ADDENDUM NO. 2

REYNOLDSBURG CITY SCHOOLS
L.F.O. ATHLETIC & ECO LAB PROJECTS

Date: **March 30, 2011**

Addendum No. 2 to the Drawings and Project Manual, dated **March 17, 2011**, for **L.F.O. ATHLETIC & ECO LAB PROJECTS**, Reynoldsburg City Schools, 7244 East Main Street, Reynoldsburg, Ohio 43068; as prepared by Moody Nolan, Inc., 300 Spruce St. Suite 300, Columbus, OH 43215.

SOIL, WASTE, & VENT DIAGRAM
 SCALE: NONE

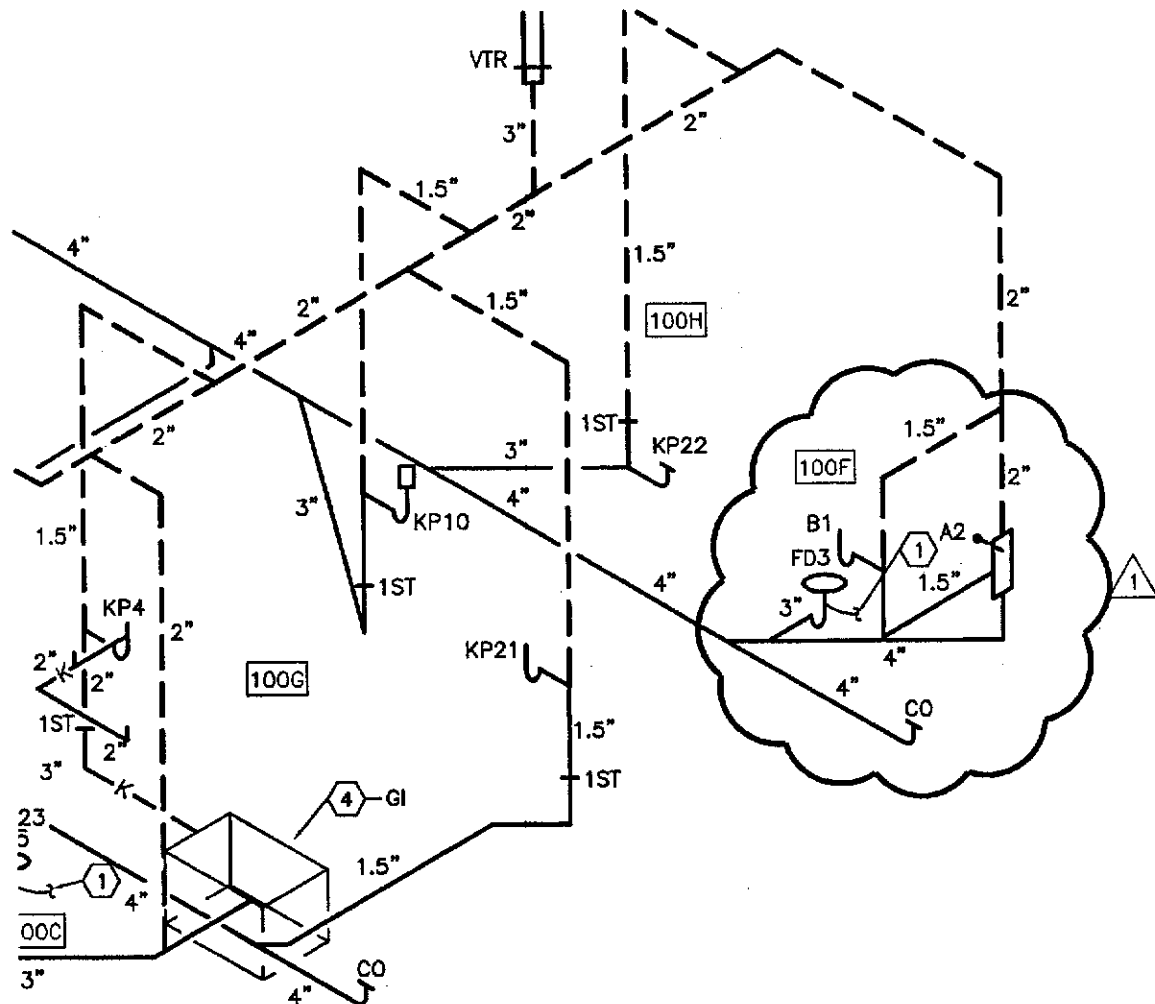
- a. Revise Soil, Waste and Vent Diagram per attached sketch P-SK04.
- Item 2-20 Sheet T0.01 Vol. 1:
- a. Added "R" outlet to Detail A, and description to TECHNOLOGY WITH ELECTRICAL REQUIREMENTS. Refer to Sketch T-SK01.

SCOREBOARD SUPPORT DETAIL

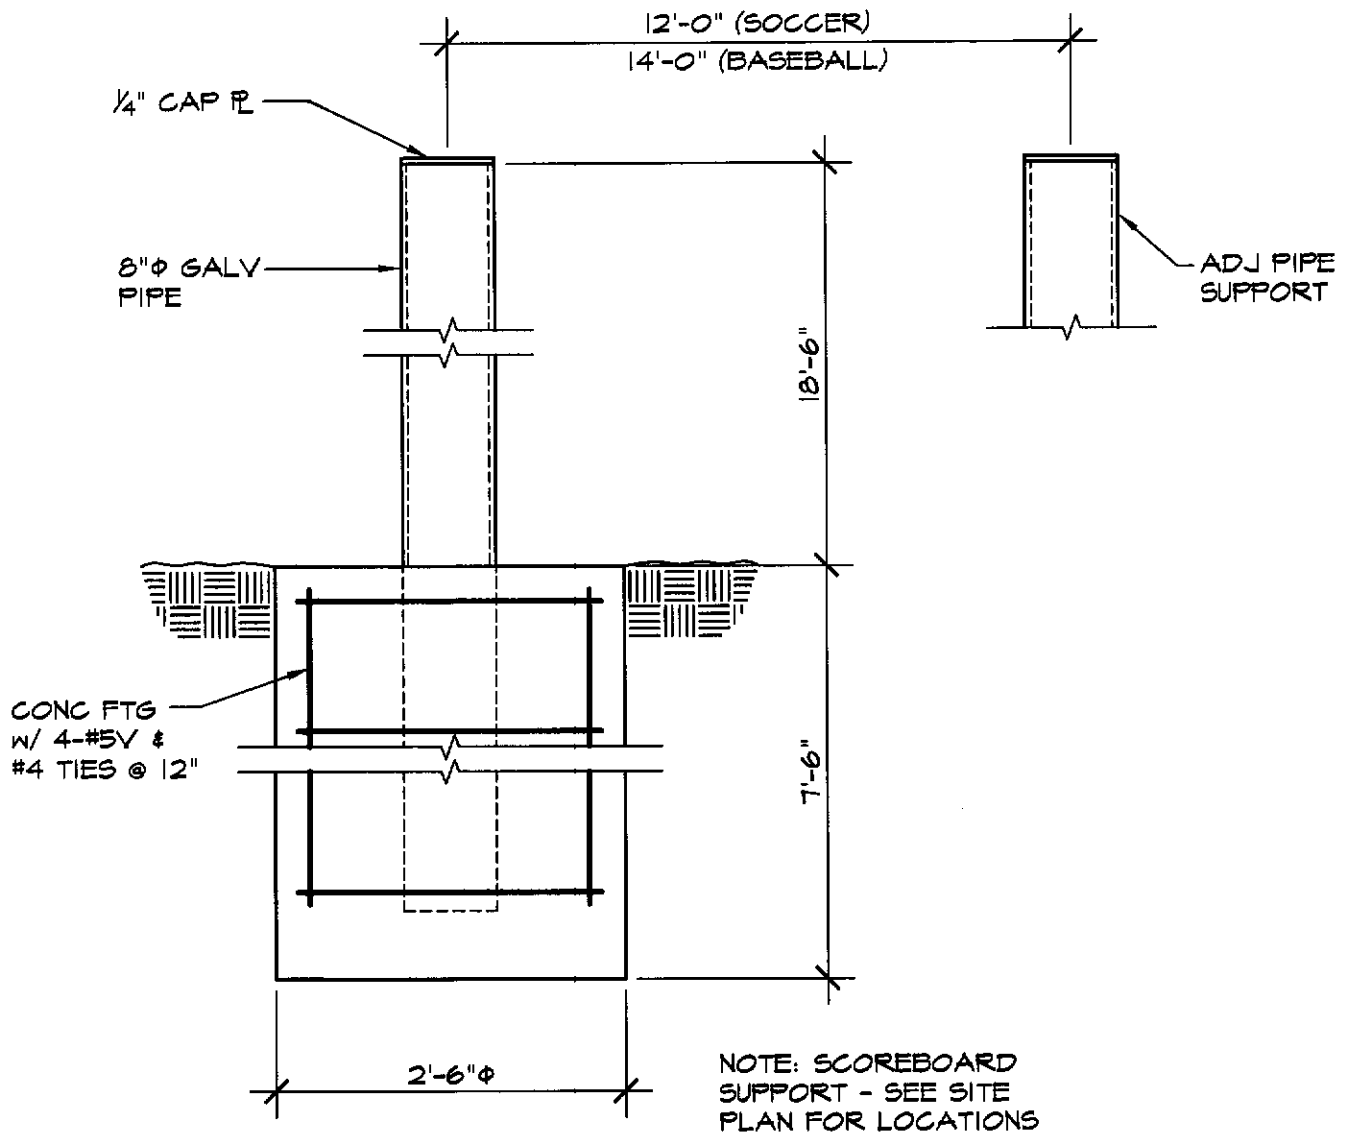
- a. Revise detail 6/sf1.1. See attached sketch S-SK01.

ISSUED WITH ADDENDUM 2	SHEET REVISED Sa1.2
SKETCH NUMBER S-SK02	
PROJ# 08177.1	DRAWN BY SMBH
DATE 3/30/11

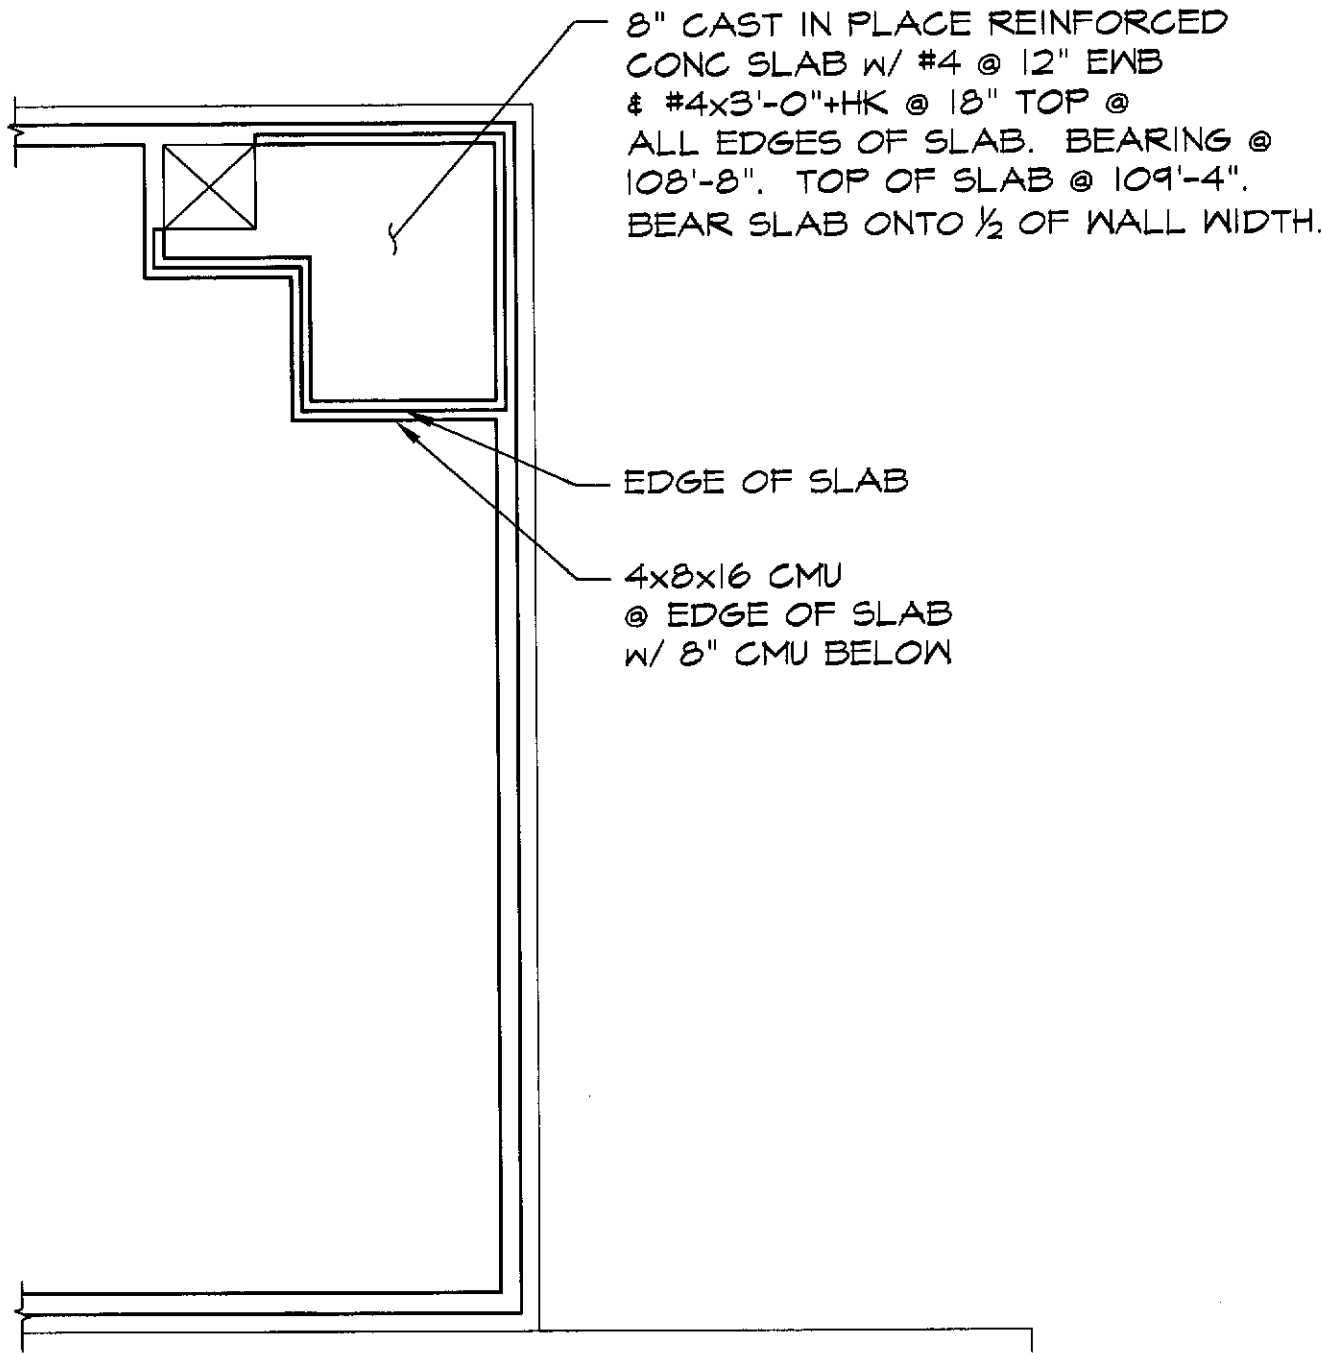
- a. Add mezzanine framing plan to sheet. See attached sketch S-SK02.
- Item 2-23 Sheet Cs1.3 Vol. 2:
- a. **Clarification:** The bleacher concrete pads at the tennis courts are **not** in this package. The bleacher concrete pad at the softball field **shall** be included in the base bid of BP 251. Pad shall be 38' x 12' and shall have ODOT Item 451 – 8" reinforced concrete pavement and ODOT Item 304 – 8" aggregate base. Bleachers at tennis courts and softball are to be included in BP 251.

8" CAST IN PLACE REINFORCED
 CONC SLAB W/ #4 @ 12" EWB
 & #4x3'-0"+HK @ 18" TOP @
 ALL EDGES OF SLAB. BEARING @
 108'-8". TOP OF SLAB @ 109'-4".
 BEAR SLAB ONTO 1/2 OF WALL WIDTH.

ISSUED WITH ADDENDUM 2	SHEET REVISED Ta1.11
SKETCH NUMBER T-SK02	
PROJ # 08177.1	DRAWN BY KMB
DATE 3/30/11

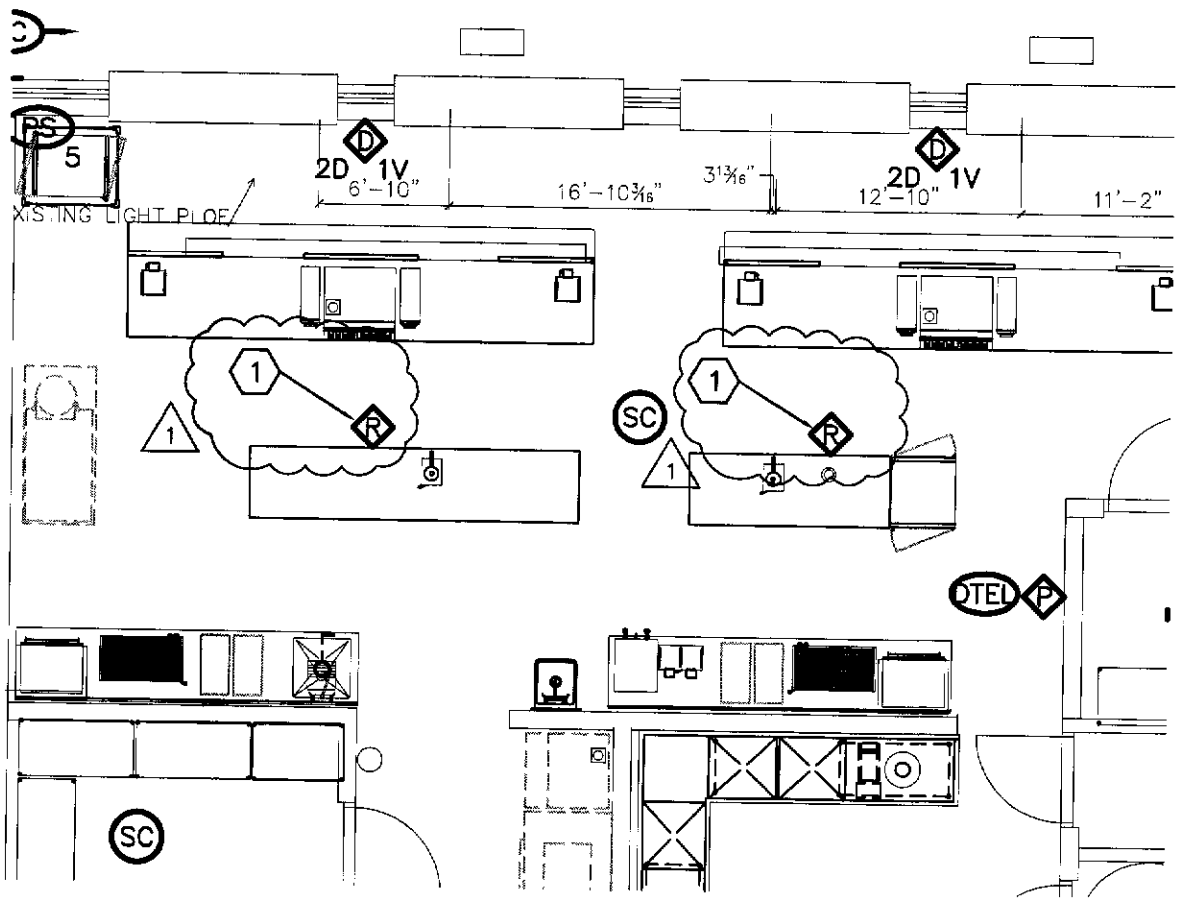
- Item 2-21 Sheet Ta1.11 Vol. 1
- a. Added two "R" outlets and associated Plan Note to FIRST FLOOR TECHNOLOGY PLAN. Refer to Sketch T-SK02
- Item 2-22 Sheet Sa1.2 Vol. 1

1 OUTLETS TO BE VERTICALLY MOUNTED ON SOFFIT ABOVE.
